**Subject: Water and Waste Water System Improvements
North Central Ag Park Expansion – Water System Improvements
2011, Phase B: Water Treatment Plant Section 1: High Service
Pumps and Stand-by Power – Change Order #5 – Rice Lake
Construction**

SUMMARY OF CHANGE ORDER #5

REPLACEMENT SECTIONS

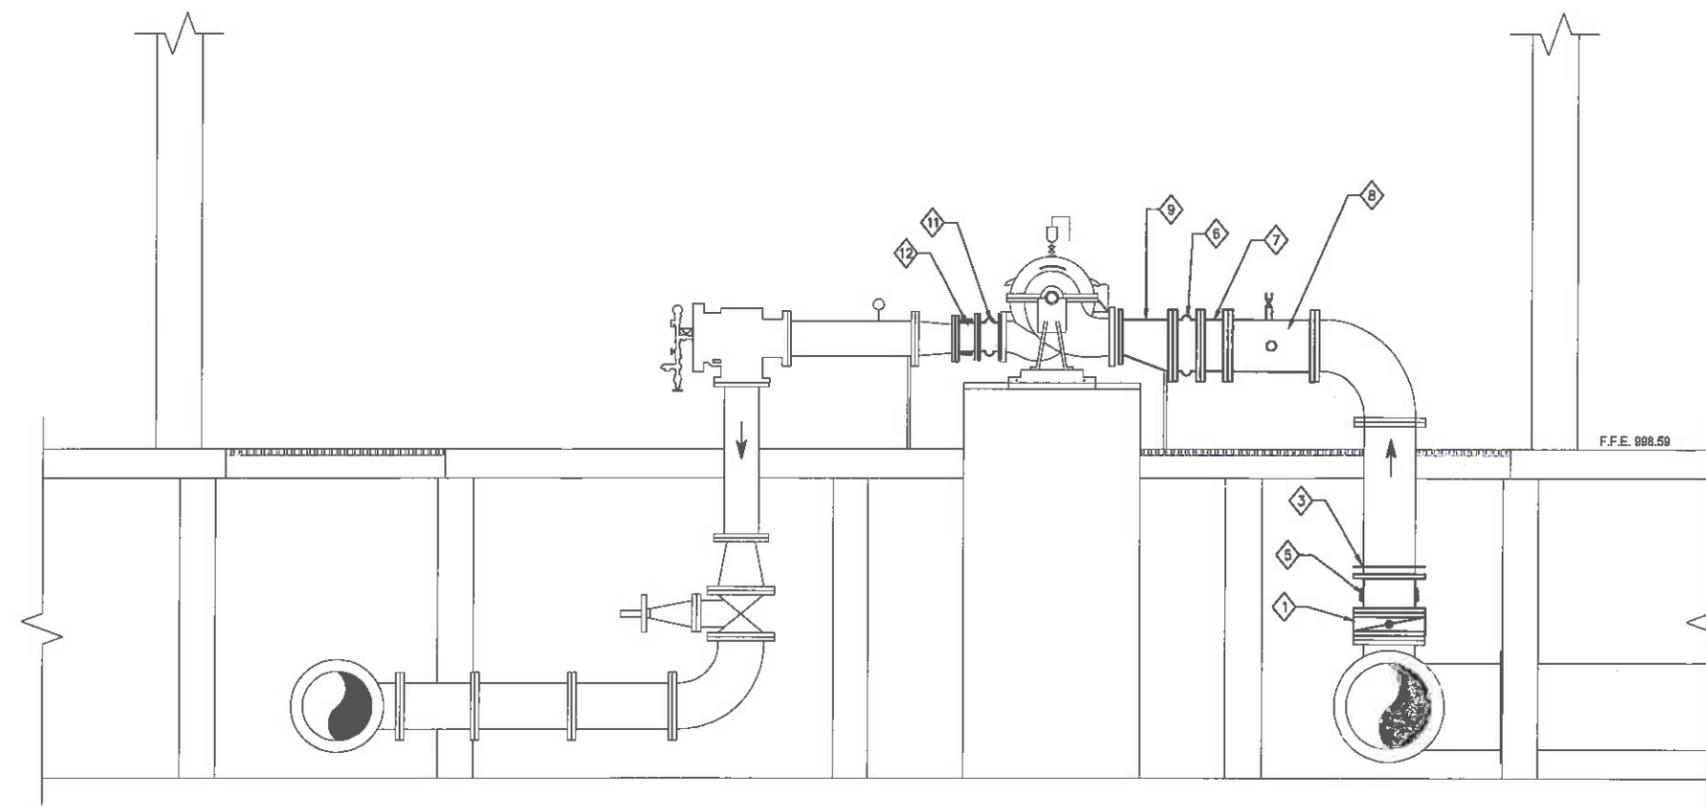
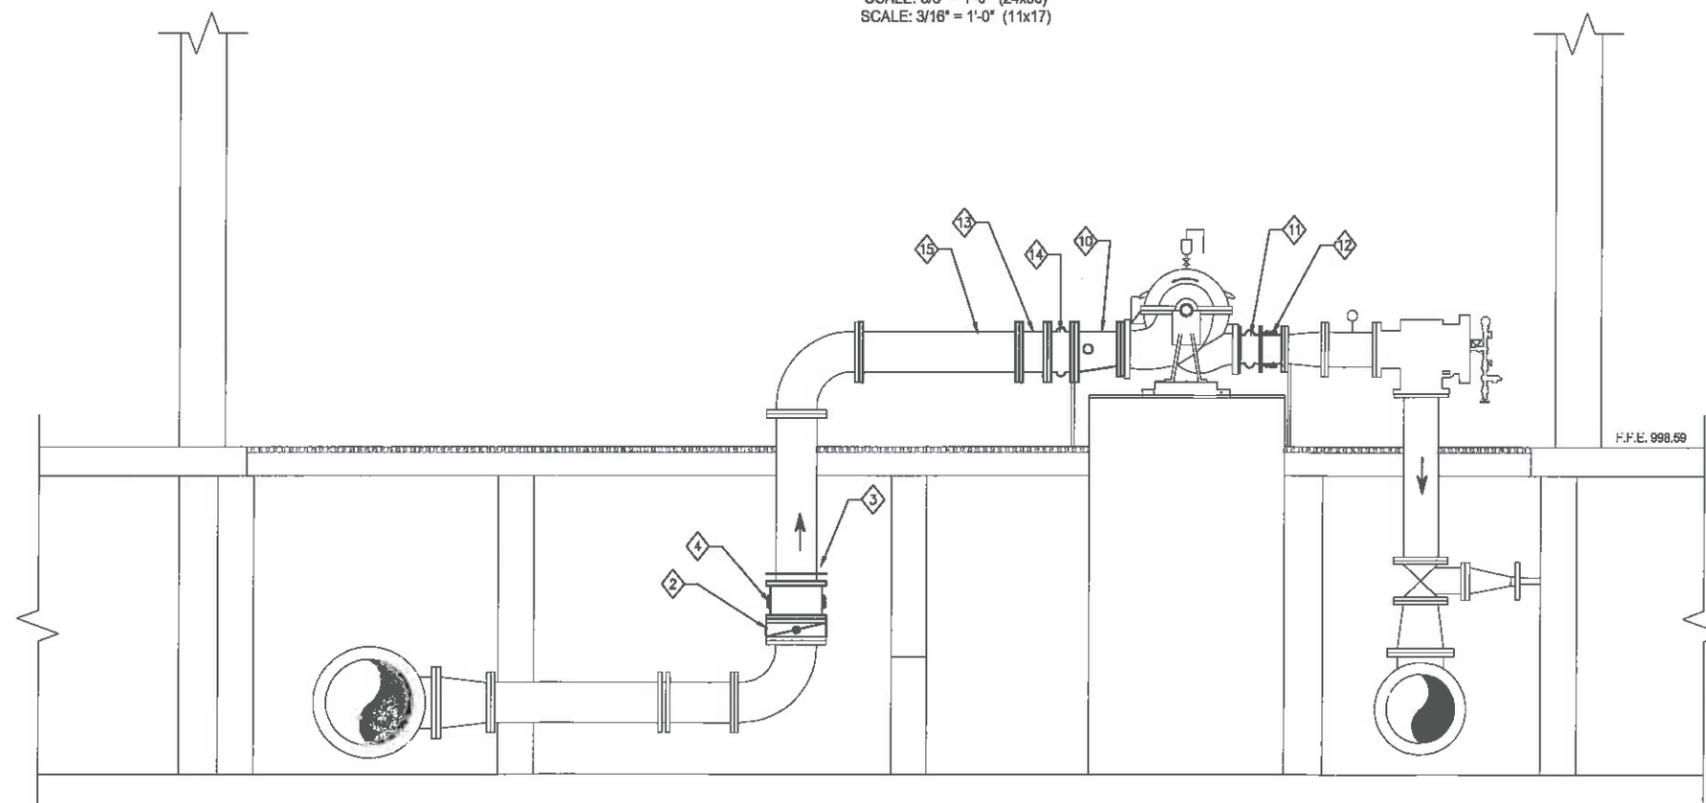
- ① RE-INSTALLED 18" BUTTERFLY VALVE. INSTALL WITH STEM PARALLEL TO N-S PLANE.
- ② RE-INSTALLED 14" BUTTERFLY VALVE. INSTALL WITH STEM PARALLEL TO N-S PLANE.

- ③ CUT PIPE AT NECESSARY LOCATION TO INSTALL COUPLING.
- ④ 14" FLANGED COUPLING ADAPTER.
- ⑤ 18" FLANGED COUPLING ADAPTER.
- ⑥ NEW 18" RUBBER EXPANSION JOINT. PROCO STYLE 231 FA, OR EQUAL.

- ⑦ NEW 18" DI SPOOL.
- ⑧ EXISTING 18" DI PIPE WITH THREADED TOPS RE-INSTALLED DIRECTLY TO 18" 90° BEND.
- ⑨ 18"x12" ECCENTRIC REDUCER.
- ⑩ 14"x12" ECCENTRIC REDUCER WITH 3/4" TAPS ON TOP AND SIDE. RE-INSTALL EXISTING PRESSURE GAUGE AND AIR RELEASE VALVE.

- ⑪ 10" RUBBER EXPANSION JOINT. PROCO STYLE 231 FA, OR EQUAL. 250# BOLT PATTERN.
- ⑫ RE-INSTALL EXISTING 10" FLANGED COUPLING ADAPTER AT REDUCED LENGTH.

- ⑬ NEW 14" DI SPOOL.
- ⑭ NEW 14" RUBBER EXPANSION JOINT. PROCO STYLE 231 FA, OR EQUAL.
- ⑮ EXISTING 14" DI PIPE WITH THREADED TOPS RE-INSTALLED DIRECTLY TO 18" 90° BEND.
